# User's Manual Errata

Please note the following corrections to the User's Manual.

## Section 1.2

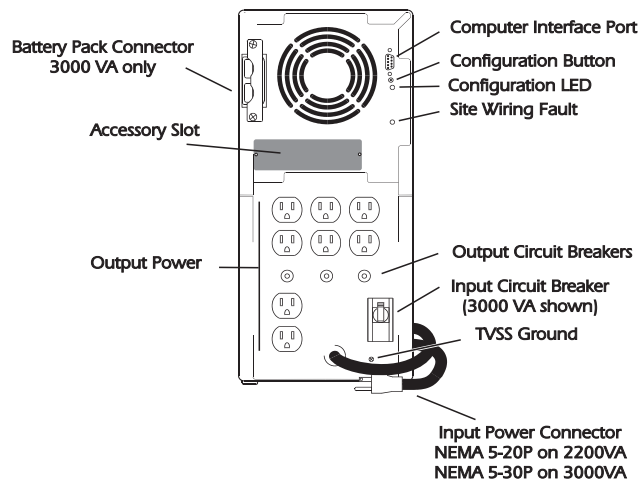
For 2200 VA and 3000 VA models add the following:

**WARNING:** Changes or modifications to this unit not expressly approved by the party responsible for compliance could void the user's authority to operate the equipment.

**NOTE:** This equipment has been tested and found to comply with the limits for a Class A digital device pursuant to Part 15 of the FCC Rules. These limits are designed to provide reasonable protection against harmful interference when the equipment is operated in a commercial environment. This equipment generates, uses, and can radiate radio frequency energy and, if not installed and used in accordance with the instruction manual, may cause harmful interference to radio communications. Operation of this equipment in a residential area is likely to cause harmful interference in which case the user will be required to correct the interference at his own expense.

Shielded signal cables must be used with this unit to ensure compliance with the Class A FCC limits.

## Section 4.3

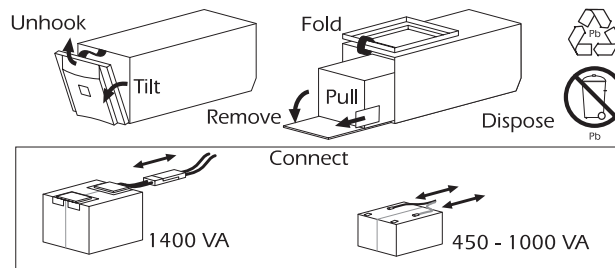
Change to read:

Some UPS accessories connect to the computer interface (DB-9) port, while others install in the accessory slot. See the literature accompanying the accessory to determine proper installation. The screws holding the slot cover are #2 Phillips head type.

To use the computer interface port, connect the accessory to the DB-9 connector and tighten down the connector's screws.

Connect the optional battery pack (3000 VA model only) according to the instructions with the battery pack.
